BROWNS FERRY NUCLEAR PLANT (BFN) – UNITS 1, 2, AND 3 – TECHNICAL SPECIFICATIONS (TS) CHANGES TS-418 AND TS-431 – EXTENDED POWER UPRATE (EPU) – RESPONSE TO ROUND 23 REQUEST FOR ADDITIONAL INFORMATION (RAI) REGARDING STEAM DRYER SIGNAL PROCESSING (TAC NOS. MD5262, MD5263, AND MD5264)

**TENNESSEE VALLEY AUTHORITY
BROWNS FERRY NUCLEAR PLANT (BFN)
UNITS 1, 2, AND 3**

**TECHNICAL SPECIFICATIONS (TS) CHANGES TS-431 AND TS-418
EXTENDED POWER UPRATE (EPU)**

**RESPONSE TO ROUND 23 REQUEST FOR ADDITIONAL INFORMATION (RAI)
REGARDING STEAM DRYER SIGNAL PROCESSING**

Figure EMCB.203-1.6a: Cross spectra (top) and coherence (bottom) of measured data for BFN1 main steam line A, for LF conditions (black) and corresponding EIC (red).

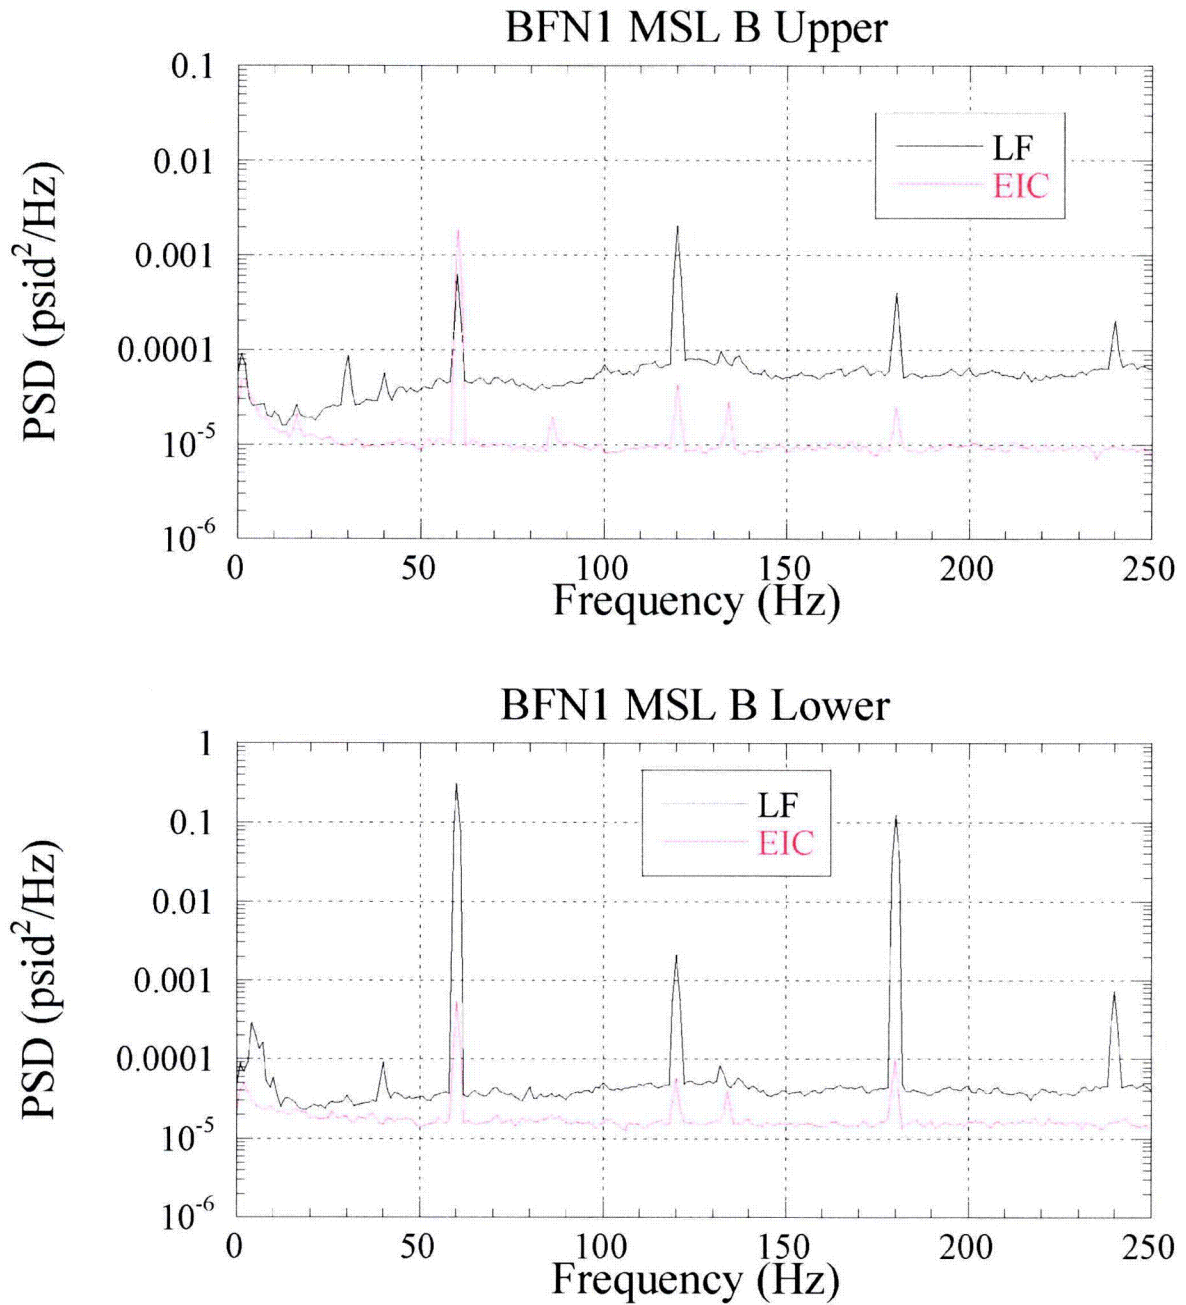
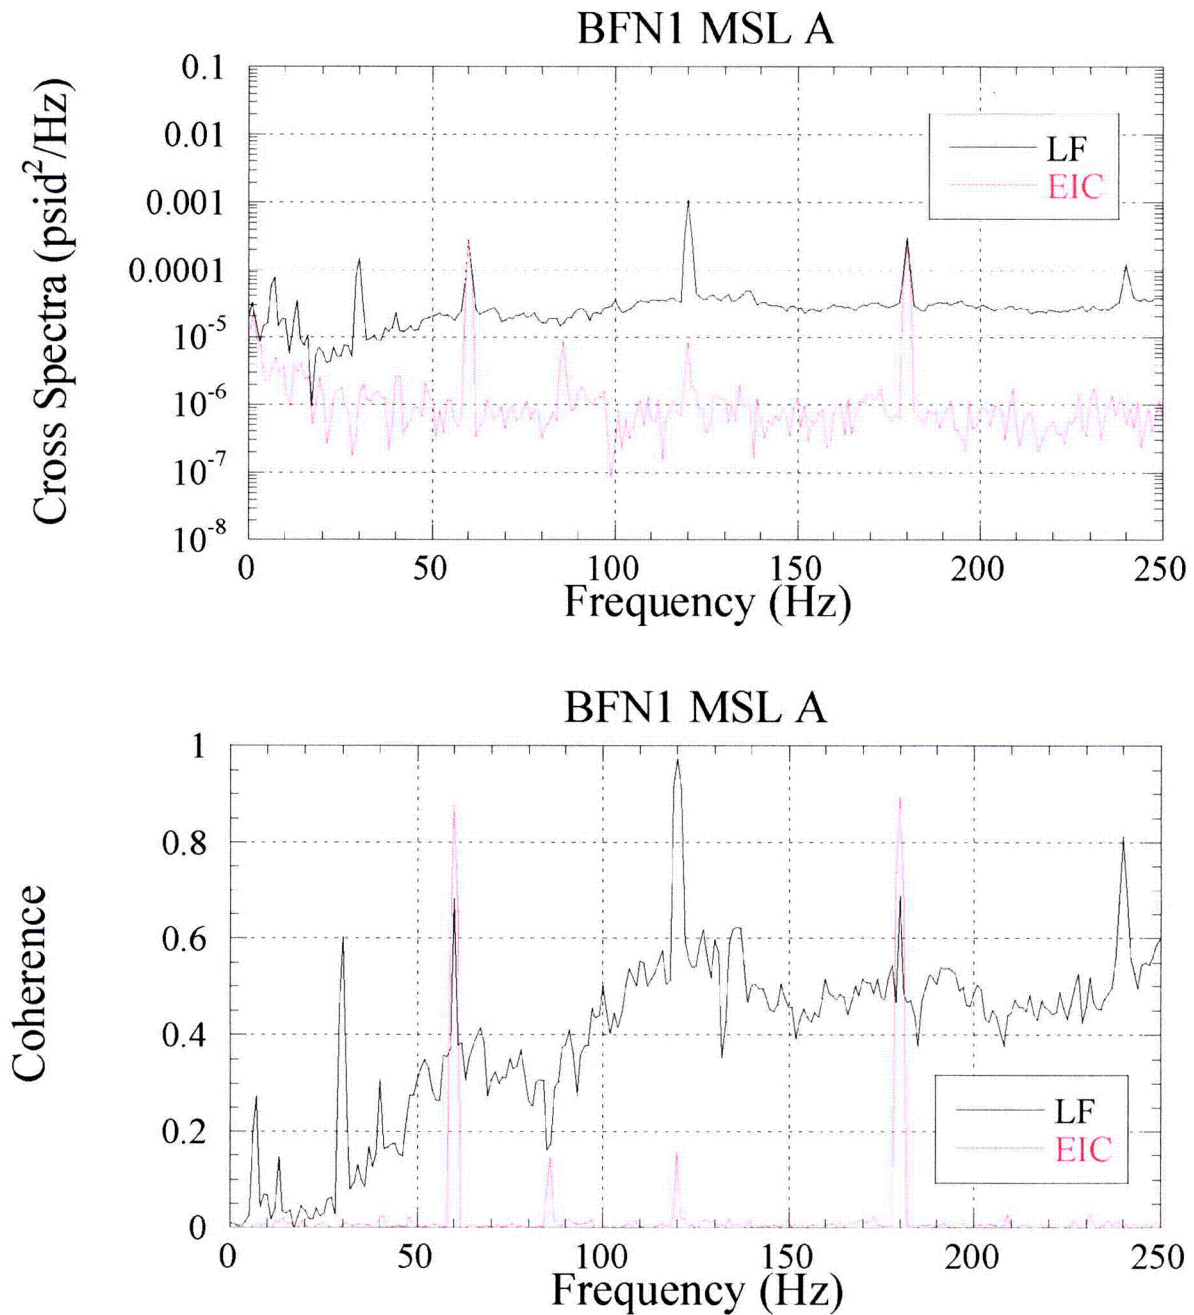
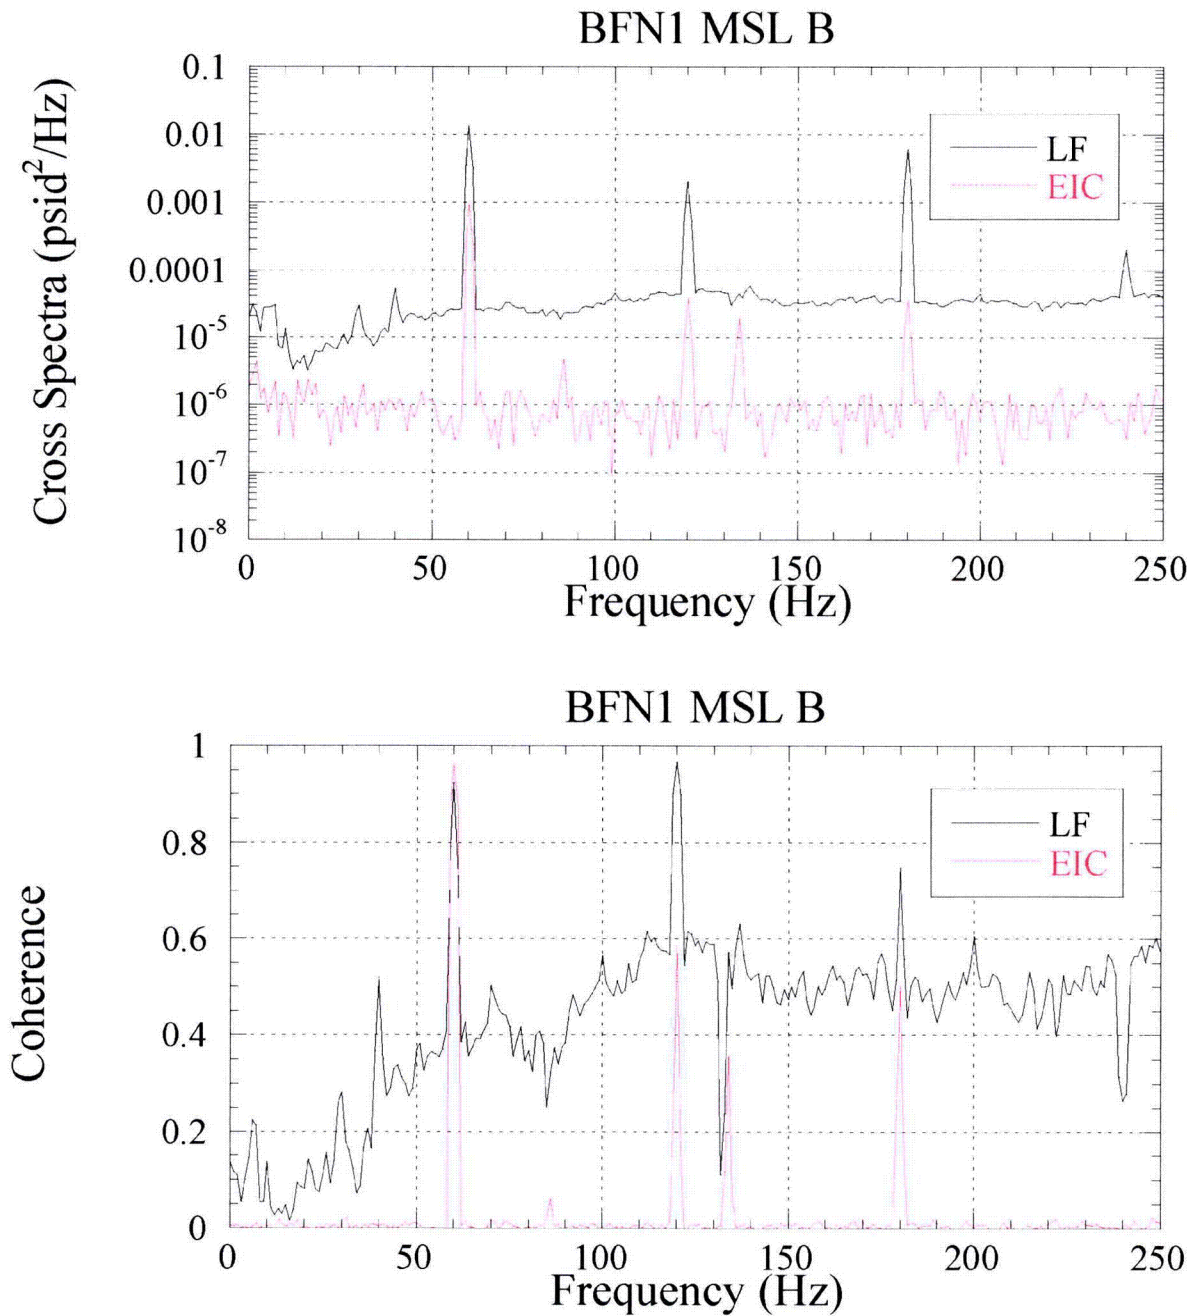
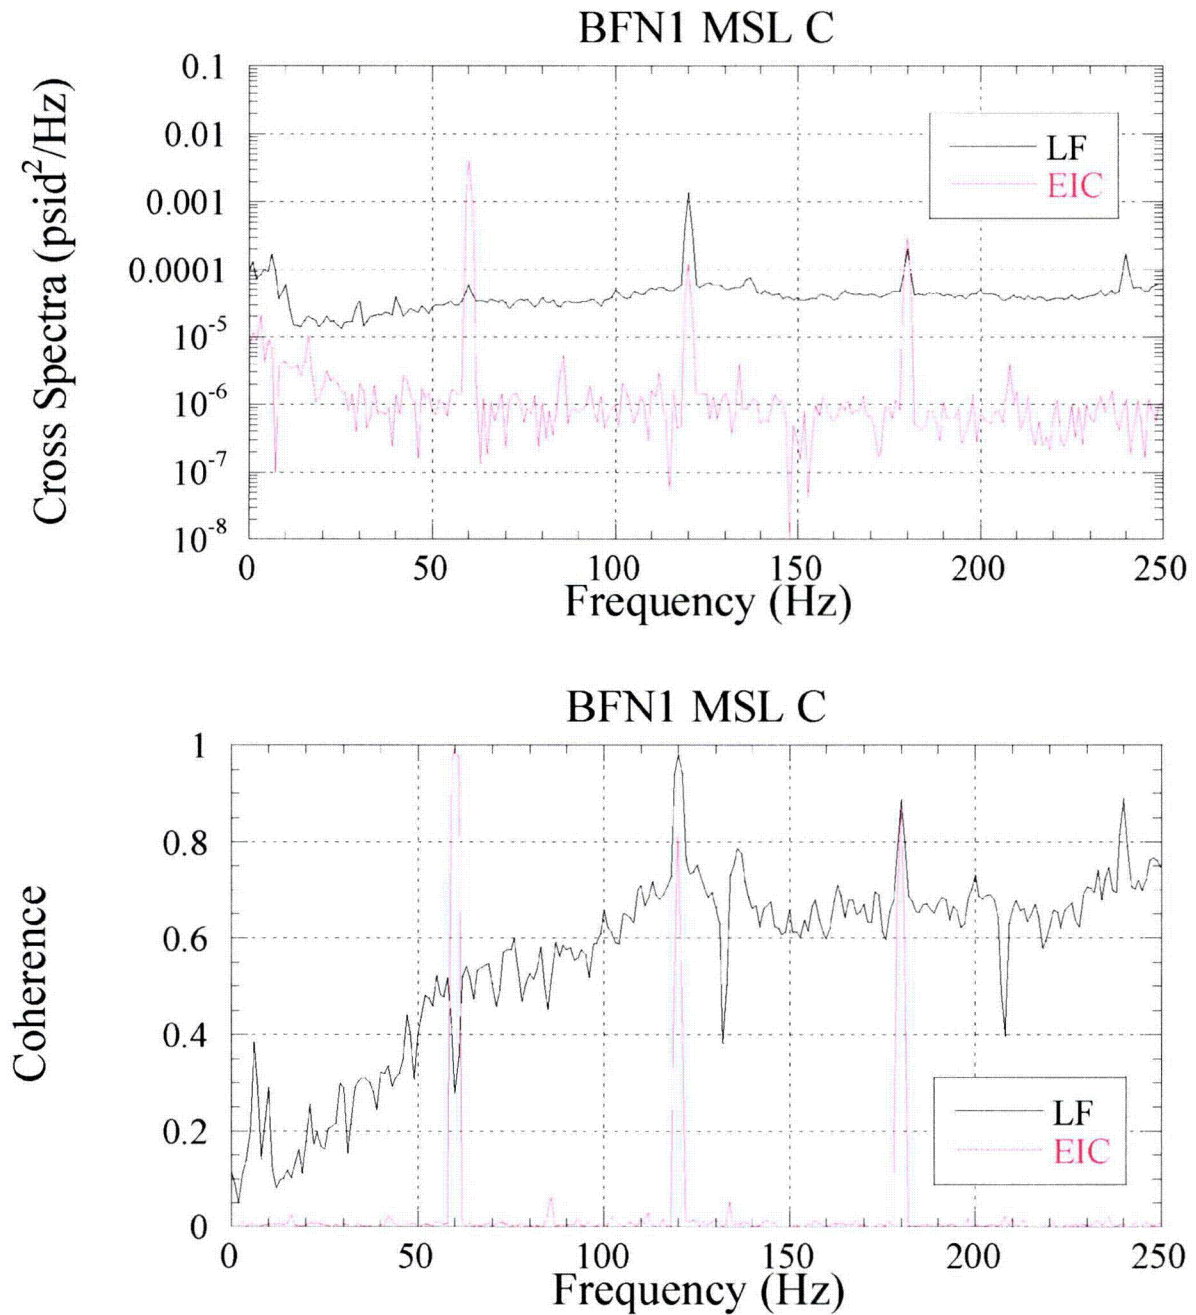
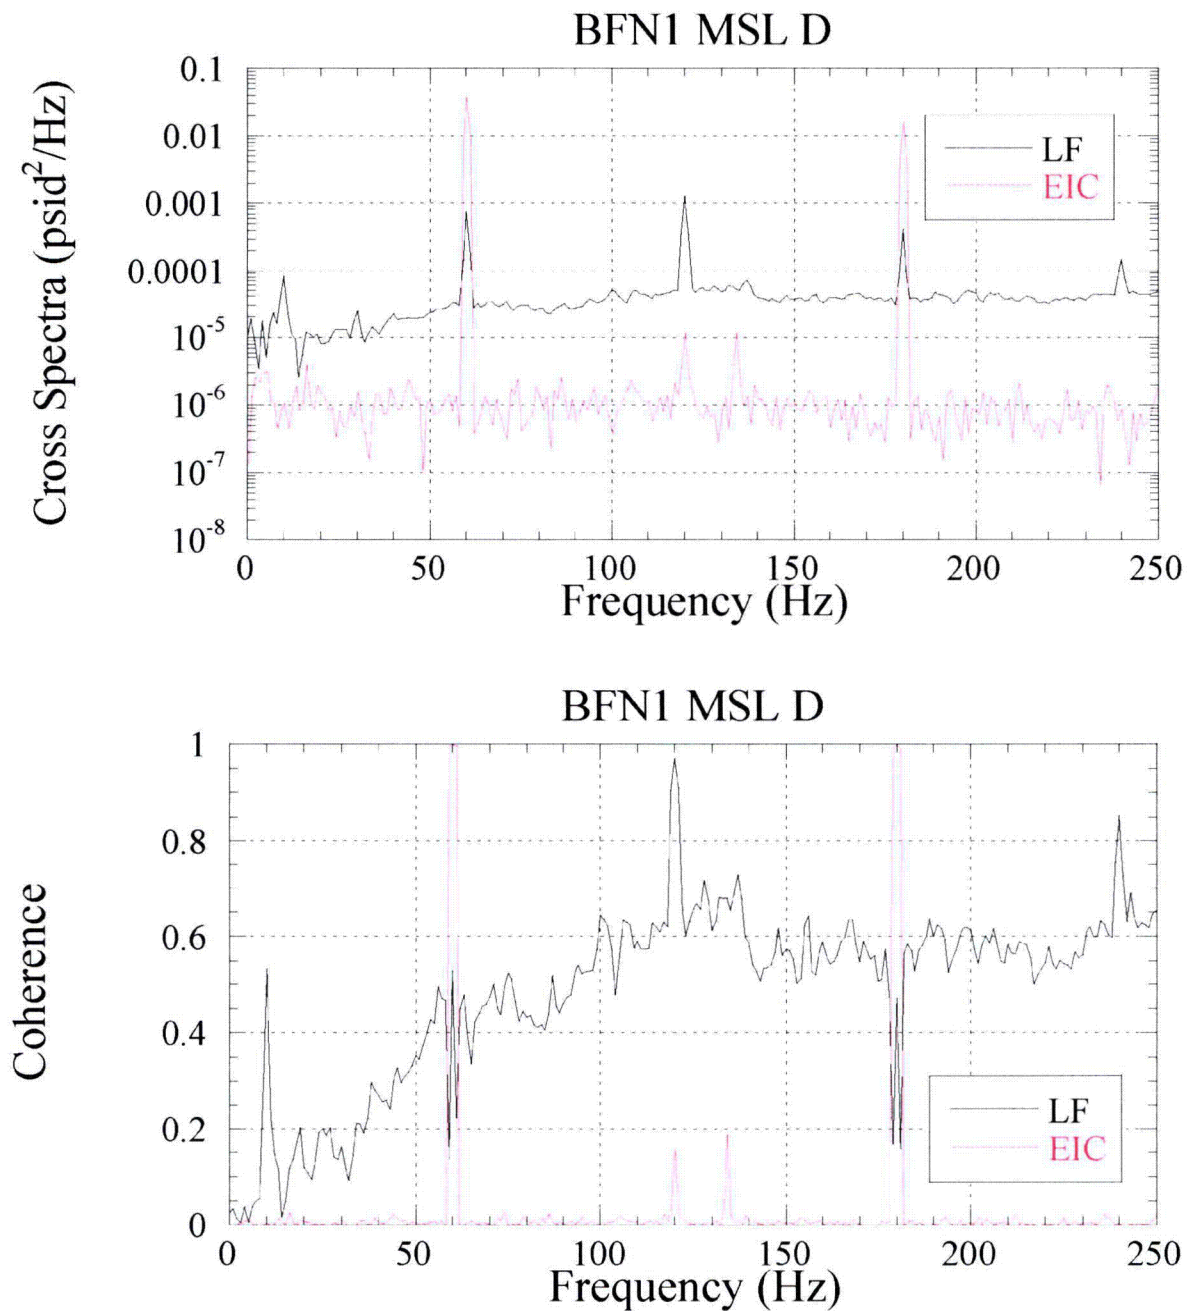
In response to EMCB.200/157., TVA presents detailed discussion of signal conditioning in six steps. Provide plots of strain gage signals (autospectra, cross spectra, coherence, and phase) and computed [[]] throughout the procedure described in their RAI response (prior to step 1, after step 1, after step 2, after step 4 and after step 6), for current license thermal power (CLTP) and Low Flow (LF) signals, for Units 1 and 2.

The requested plots for Unit 1 are listed and provided below. The requested plots for Unit 2 are scheduled to be provided by January 23, 2009.
